DESIGN REVIEW COMMITTEE

AGENDA

4.I. 3240 Jackson Street Accessory Structure

DATE: April 13, 2022
TO: Tonya Hutson
FROM: Lynn Patterson
RE: **Design Review – 3240 Jackson Street Accessory Building**

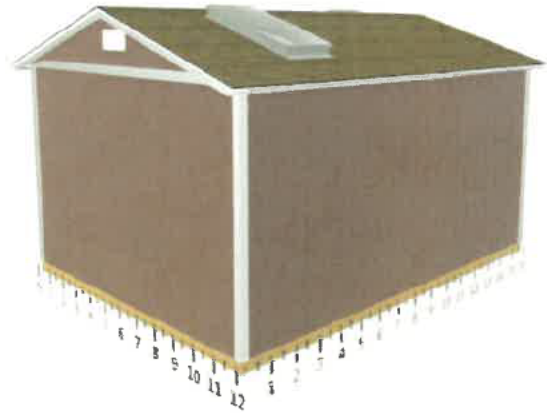
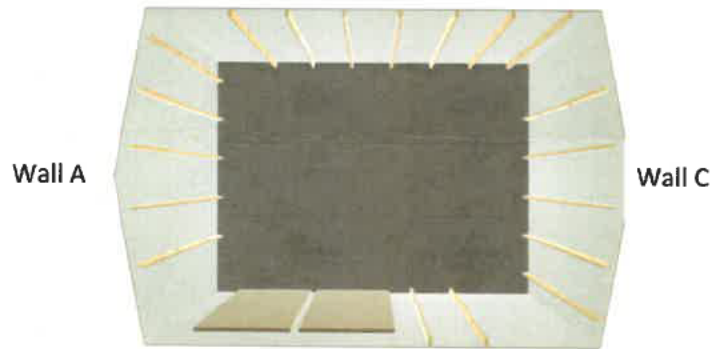
- iv. Outbuildings shall be of compatible material and architectural style to the principal building.
 - The application lists T1-11 siding.
 - The proposed renderings show vertical siding compared to the lap siding on the dwelling.

- v. Outbuildings shall have a minimum height of 14 feet and a maximum height of that of the principal building or 25 feet, whichever is less.
 - No height has been provided.

- vi. Outbuildings shall be set a minimum of ten feet from any other outbuilding on adjoining lots.
 - The application does not show if there are any outbuildings within 10' of the outbuilding.

1. The included materials list describes the siding as T1-11 – the DRC should determine whether this is compatible to cementitious siding.
2. The proposed renderings show vertical siding versus lap siding used on the primary dwelling.
3. The height of the outbuilding has not been provided (14' min, 25' max).
4. The applicant has not indicated if any other buildings are within 10' of the proposed outbuilding.
5. Outbuilding must be placed on a permanent foundation.

1 PROPOSED LEFT ELEVATION
PA02 SCALE: 1/4"=1'-0"

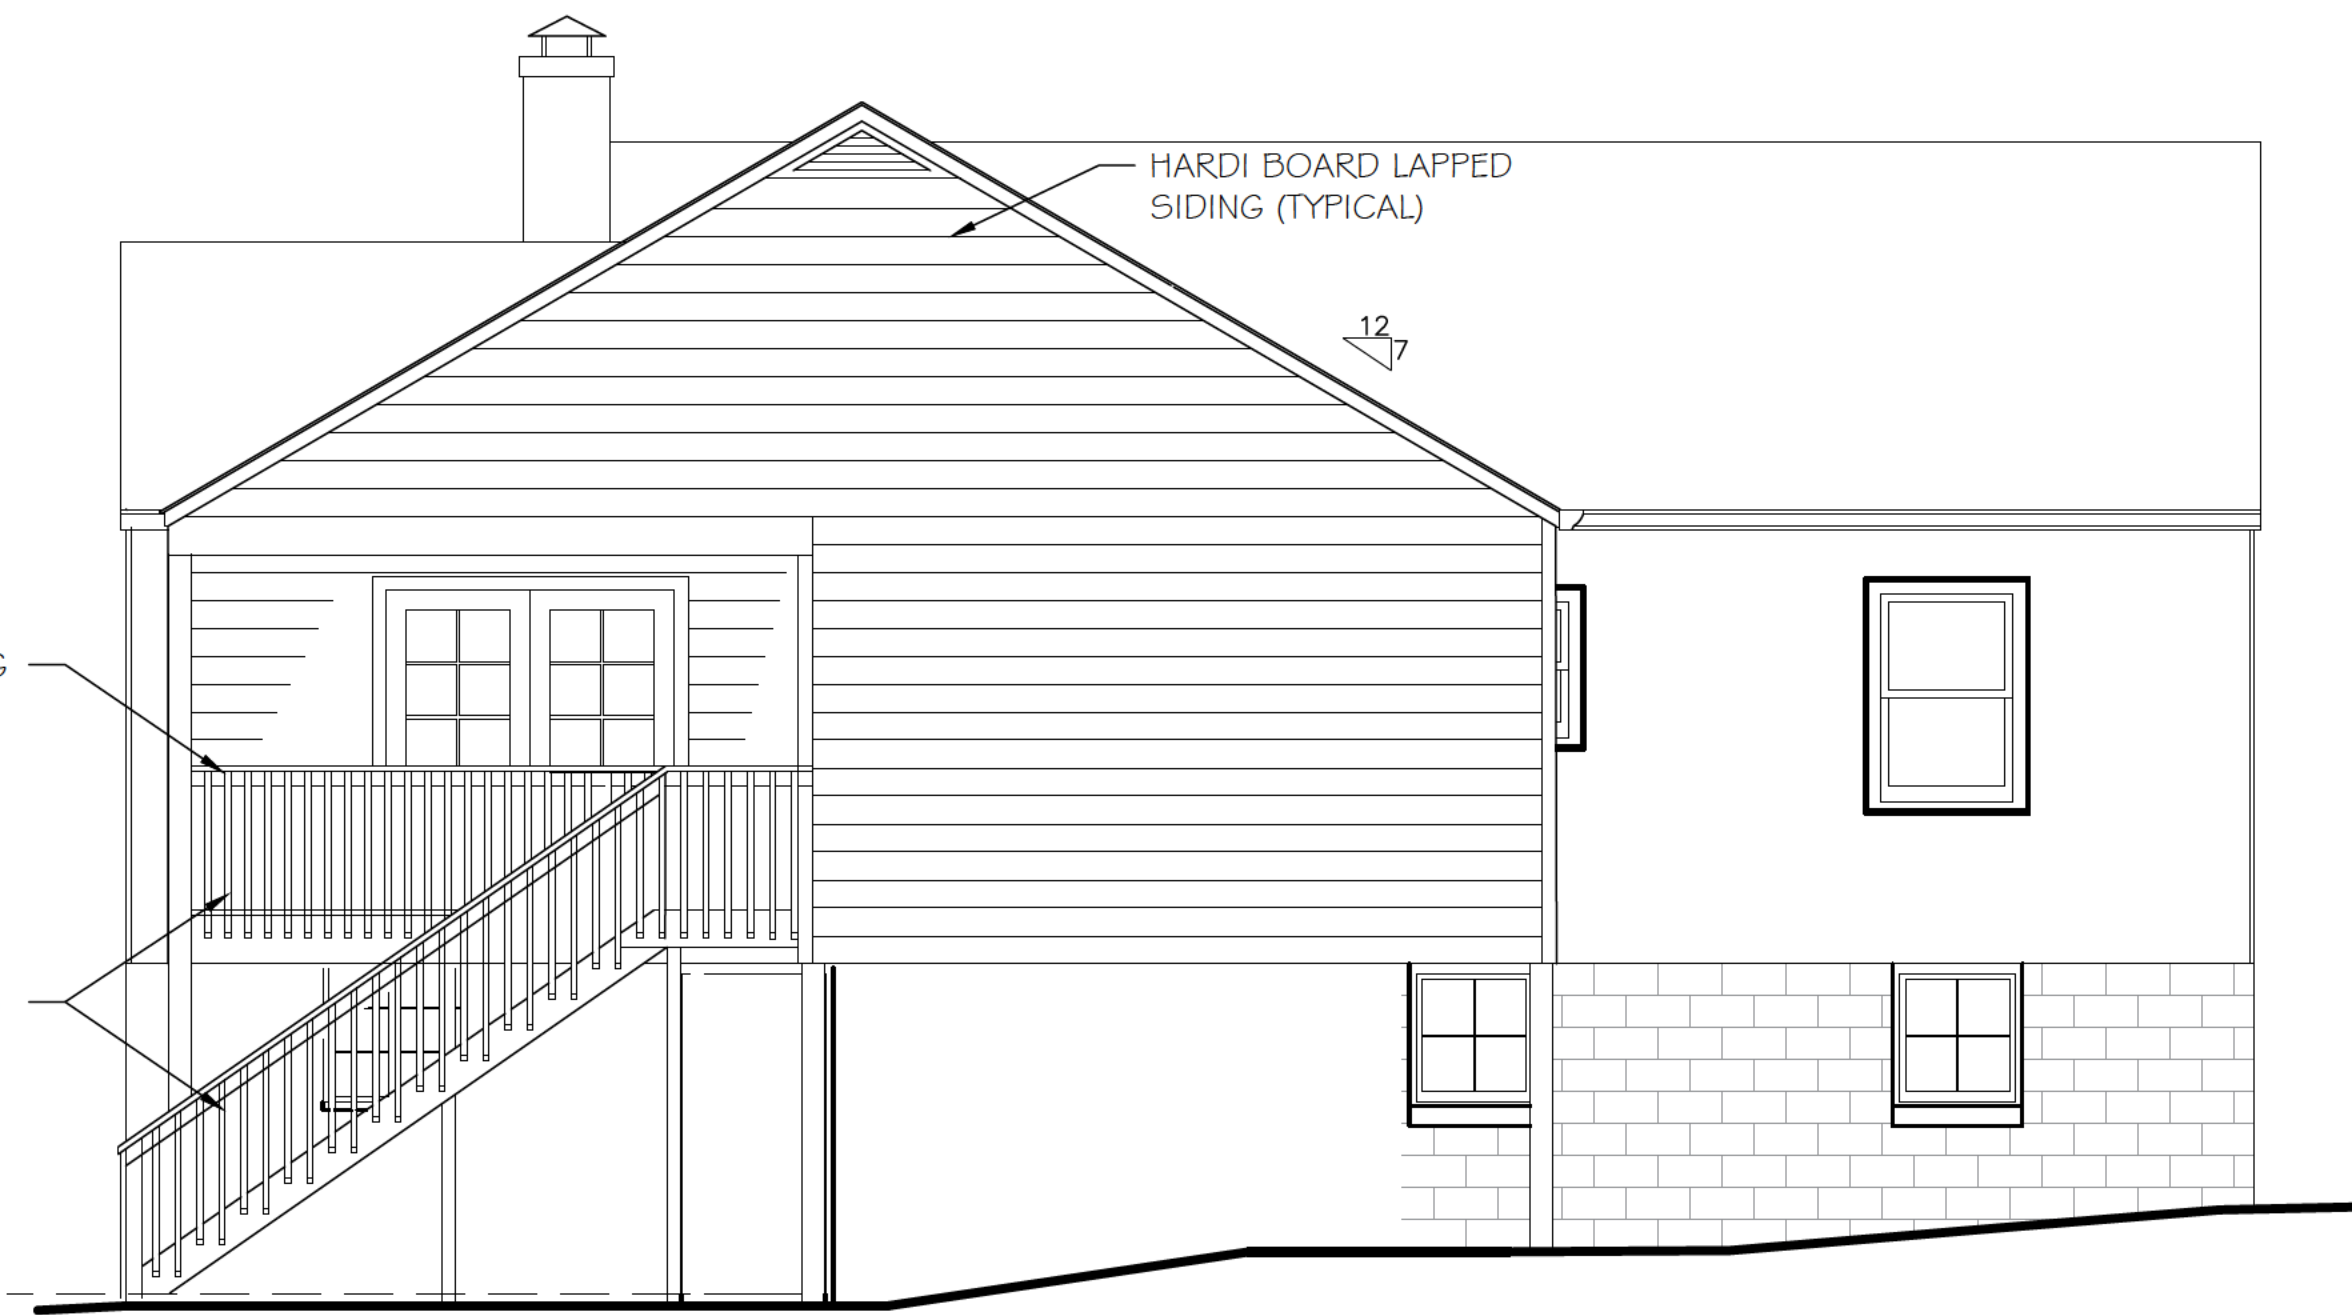
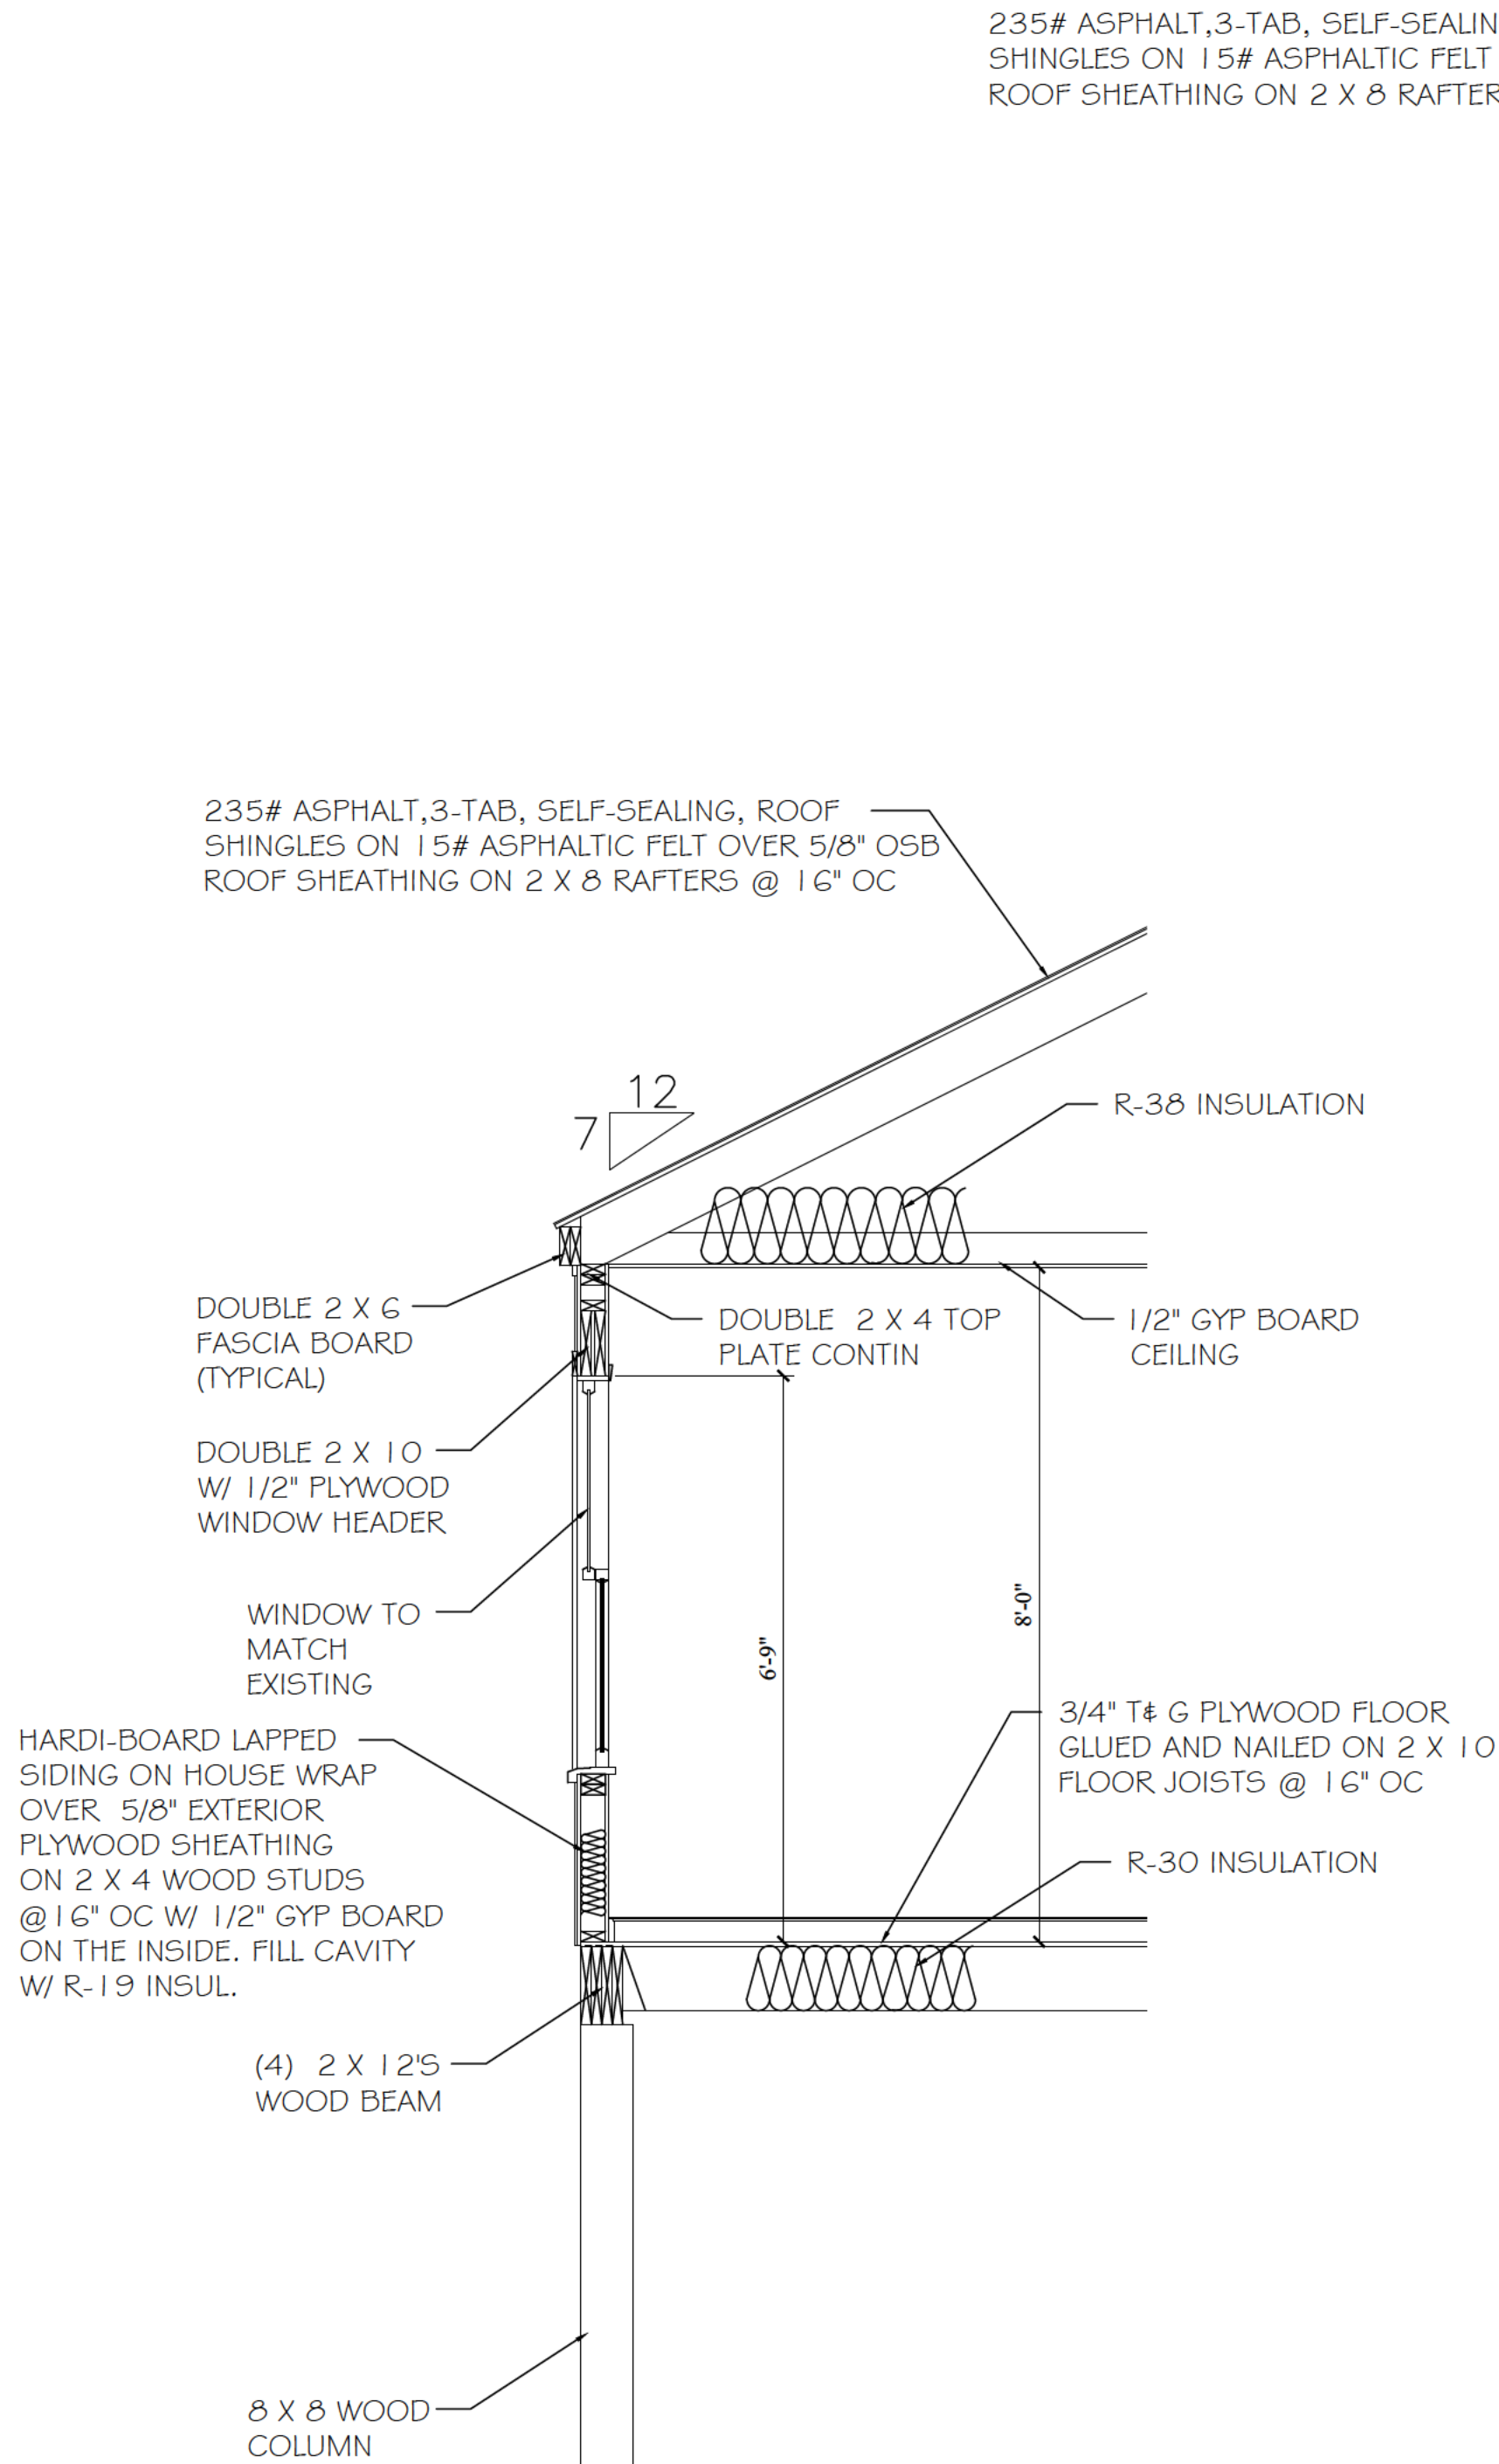
- Mechanical must be shown and screened if visible from right of way.
- Roof shingle warranty should be specified as 30 years.
- Railing design does not meet standard (lower element/railing not shown).
- Building numbers required.
- Porch finish not provided.
- Provide detail for windows to ensure standards are met.
- Provide trim detail (to meet standards).
- Show sill and provide sill material.
- Roof overhang standard is minimum of 1'. If acceptable (to match existing overhang- not dimensioned), Design Exception is required.
- Porch as percentage of façade should be detailed. Design exception required for 80% to 100% standard.
- Distance between columns exceeds 8' on center. If acceptable, Design Exception is required.
- Comply with arborist requirements.

1 PROPOSED FRONT ELEVATION
PA03 SCALE: 1/4"=1'-0"

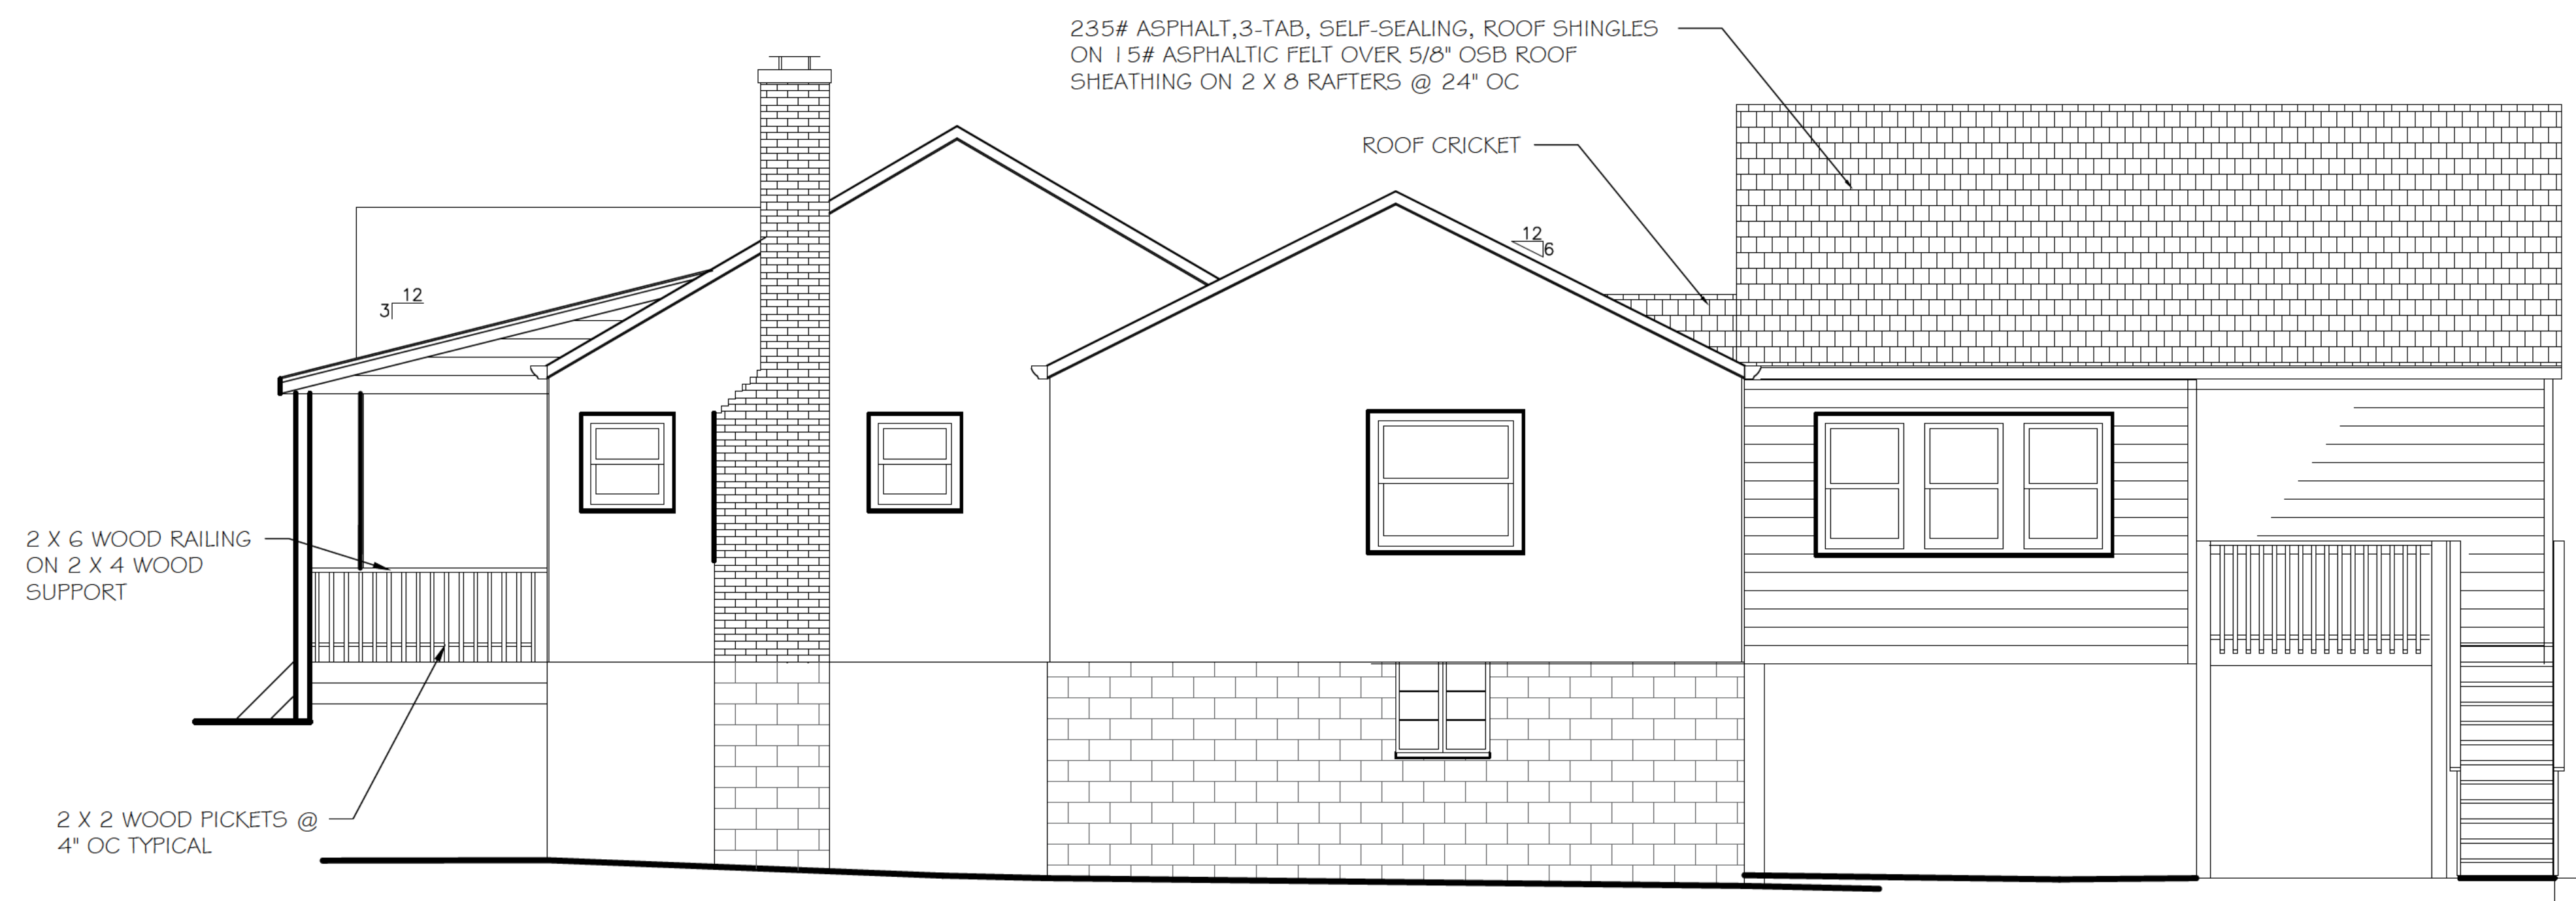
STAFF COMMENT: No building numbers shown. No detail has been provided for window recess. No detail has been provided for trim (dimensions). No sills shown or sill material.
